Council Meeting

Meeting Date 19/02/2014

Item Number:	ORD09
Subject:	ASSESSMENT OF 152-206 ROCKY POINT ROAD, KOGARAH (DARRELL LEA SITE) PLANNING PROPOSAL
File Number:	F13/274
Report by:	Coordinator Urban Strategy (Jacky Wilkes)
Contributors:	Manager Urban & Environmental Strategy (Erika Roka)
Community Engagement:	Yes
Financial Implications:	No

Figure C - Proposed height changes to RLEP 2011 (revised planning proposal)

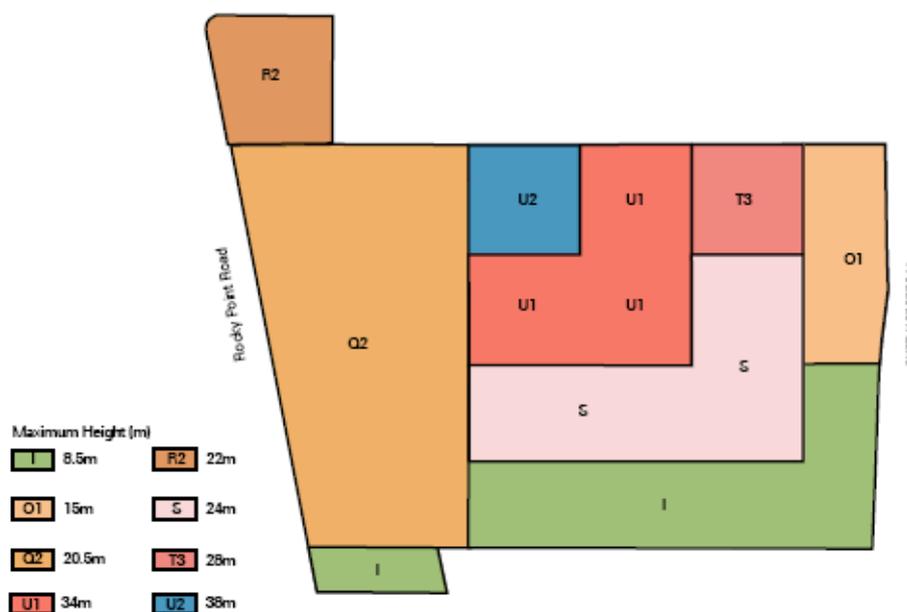
Figure 15 in the revised planning proposal illustrates the proposed height changes to the Building Heights Map. However, there is inconsistency with the descriptions at Table 2 (p.14) in the planning proposal. These heights in the Table 2 state:

- a 23.1 metres height over the area proposing 22 metres,
- a 18.4 metres height over the area proposing 15 metres,
- a 19.25 metres height over three sites proposing 15 metres.

Therefore, it is not clear what the proposed heights are being sought across the B6 zone. Regardless, the building heights that the applicant is seeking are higher than the standard height currently applying to the B6 zone (at the Princes Highway Corridor) which is 14.5 metres.

The predominant range of building heights proposed - from 38 metres, 34 metres, 28 metres, 24 metres, and 15 metres - are significantly higher than the standard height in Council's out-of-centre areas zoned R4 High Density, which is 14.5 metres.

The height map also includes a notation "Final heights to be determined". However, an applicant must be clear on the proposed heights before lodgement of the planning proposal to Council for consideration.

Figure E - Proposed number of storeys

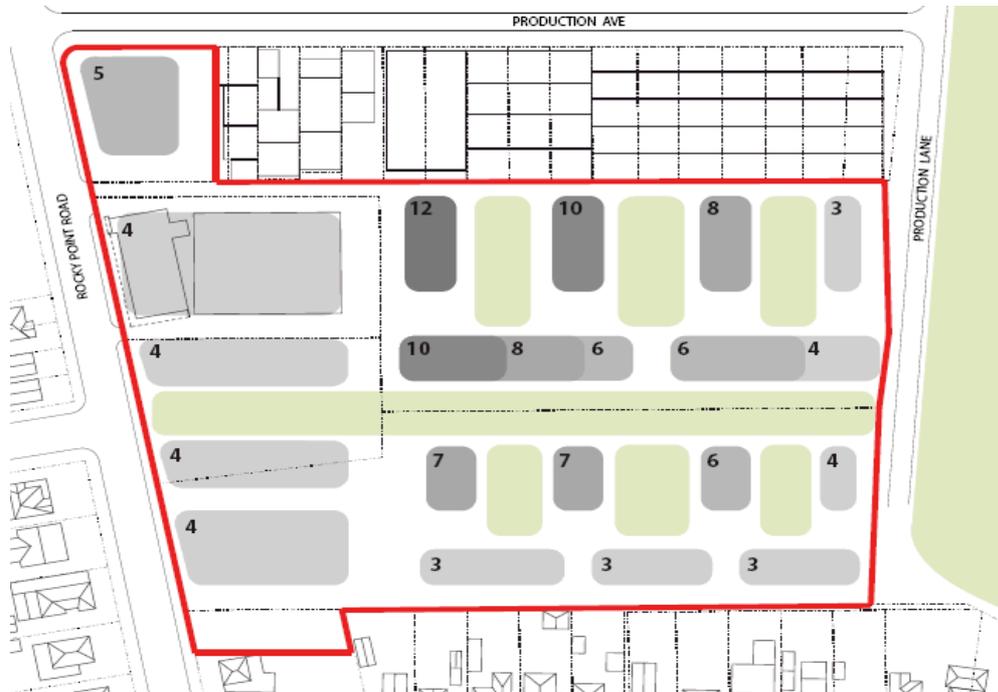
Despite these changes, the applicant's Urban Design Statement and supporting elevation drawings (refer to Attachment 2A to this report) have not been amended to reflect these changes. It means the urban design material submitted to the DP&I is identical to the material submitted earlier to Council on 30 August 2013. The accuracy of the plan drawings and elevations over the portion of the site that was coloured purple and dark brown (in the August proposal - as per figure immediately above) is in doubt.

Furthermore, Drawings 7 and 9 in Appendix B within the planning proposal, show heights stepping down (refer to Figure E above).

Figure F - Proposed floor space ratios controls for RLEP 2011

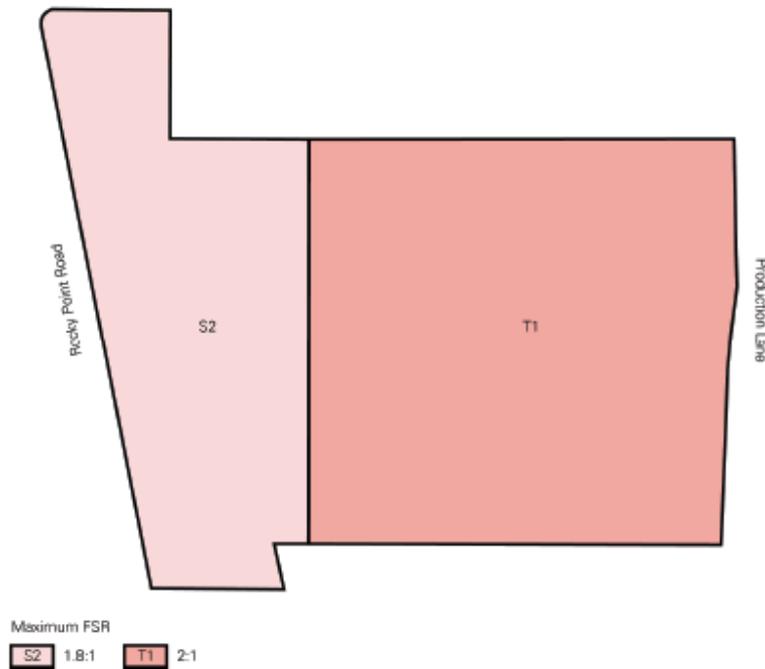
The proposed FSR of 1.8:1 is higher than that of the standard FSR for the B6 zone which is 1.5:1. The applicant's proposal does not justify the need for the increase. Refer to the detailed assessment of the proposed FSR in the section entitled "Assessment of the Proposal".

The proposed 2:1 FSR over land proposed to be zoned R4 is not illustrated in the applicant's Urban Design Statement (refer to Attachment 2A to this report) nor is it justified in the applicant's supporting elevation drawings (refer to Attachment 2B). The Urban Design analysis which support the planning proposal only tests a FSR of 1.83:1. This is evidenced by Drawing No. 8 Indicative Ground Plan (see Figure G below) the and confirmed by the applicant's architect. However, a 2:1 FSR is being sought by the applicant.

The documentation and urban design analysis submitted with the planning proposal illustrates a residential development scheme that achieves a FSR of 1.83:1. There is no explanation in the planning proposal of the rationale for a 2:1 FSR. It is noted, however, that the FSR in the nearby Ramsgate Small Village is 2:1 and this has been mentioned as the basis for the planning proposal.

The proposed FSR of 2:1 is double the standard height in Council's out-of-centre areas zoned R4 High Density (which is 1:1). Refer to the detailed assessment of the proposed FSR in the section entitled "Assessment of the Proposal".

It is recommended that for the land proposed to be zoned B6 Business Enterprise, that the FSR be reduced to 1.5:1 (and that this be reflected in the proposed Floor Space Ratio Map) and height reduced to 14.5m (4 storeys) to ensure consistency with current policy. The portion of land with a proposed height of 8.5 metres can remain unchanged. Therefore, the planning proposal should be amended in accordingly (refer also to Figure L - Proposed building heights in the urban design analysis section, below).

It is further recommended that the base FSR be 1:1, with the additional 0.4:1 only available if the development application exhibits design excellence, including excellence in sustainability achieved via a design competition. Irrespective of whether there is a design competition, a mandatory Stage 1 Development Application is recommended for the entire residential component of the site. A Stage 1 DA would determine the building envelopes and distribution of building mass across the site, the traffic and access arrangements and the arrangement of communal open and ensure the site is master-planned as a whole, rather than being subdivided into smaller parcels and developed in a piecemeal fashion.

Figure J - The applicant's proposed heights incorporating the number of storeys consistent with Rockdale DCP 2011

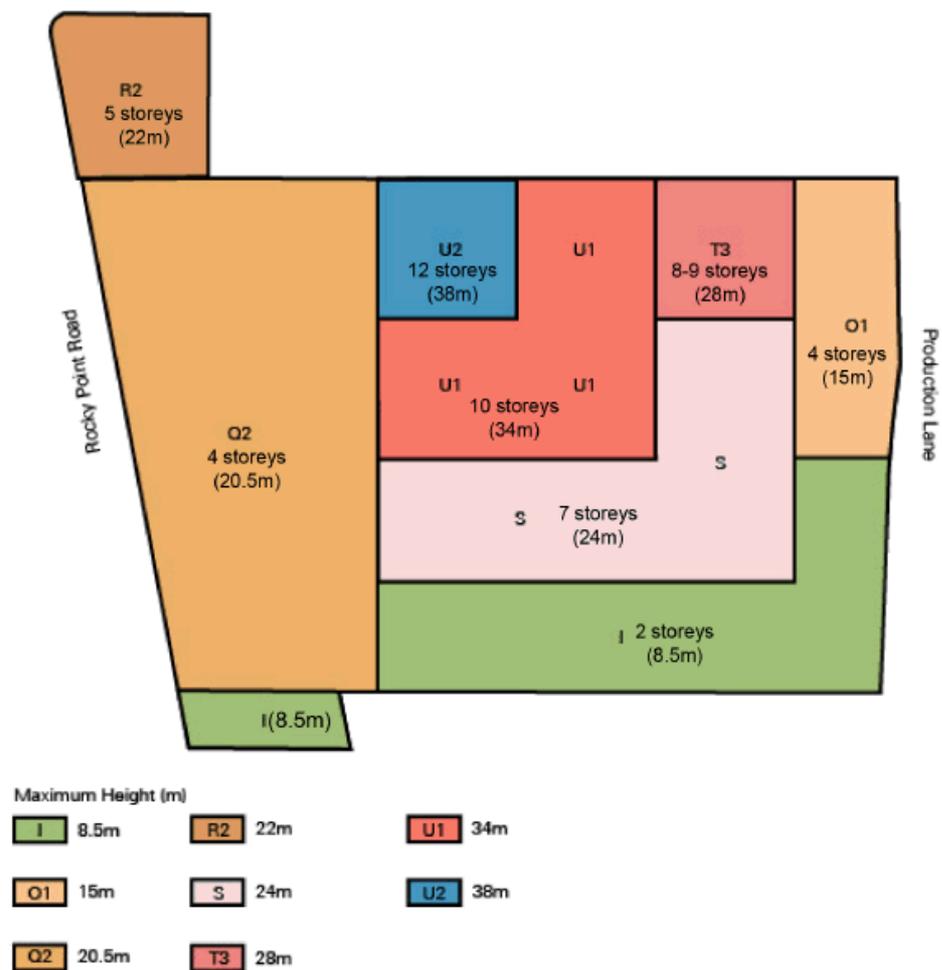
The applicant has sought to minimise the impact on surrounding residential properties by proposing a 6 metre landscaped buffer and a low density residential height limit of 8.5 metres along the southern (Margate Street) boundary. The proposed height limits then increases in 3 storey 'layers' (24m, 34m and 38m) travelling north. The height limits are also reduced toward Scarborough Park to the East. Refer to Figure J, below.

The applicant's aim is to enable the low density development to screen the higher density development until the distance from the southern (Margate Street) boundary is sufficient for the high rise development to have limited or no impact. When preparing the scheme the applicant has made note of the blank wall of the existing factory building although it is also worth noting that the existing factory building only extends two thirds of the way down the site and does not contain either windows or balconies.

- (b) for the land proposed to be zoned R4 High Density:
 - i) that the building heights be reduced as follows:
 - the 38 metre height be reduced to 31 metres;

- the 34 metre height be reduced to 24 metres;
 - the 28 metre height be reduced to 26.5 metres;
 - the 24 metre height be reduced to 17.5 metres; and
 - the 15 metre height be reduced to 12 metres,as per Figure J in this Council report.

Figure K - Elevations showing sight lines

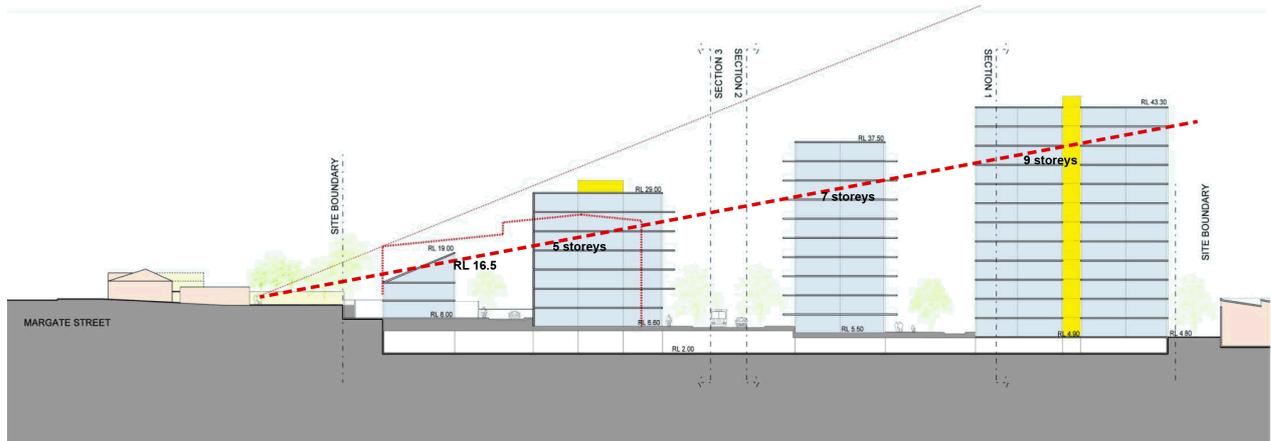
The height limits proposed by the applicant do not achieve this aim as illustrated by the (black) sight line in Figure K. The resulting development would be overbearing and would impact on the privacy of the neighbouring low density residential properties. Instead, it is recommended that the height limits be reduced as indicated by the (red) sight line in Figure K.

As a result of this analysis, it is recommended that the proposed Building Height Map be amended to reflect the height limits illustrated in Figure L, below.
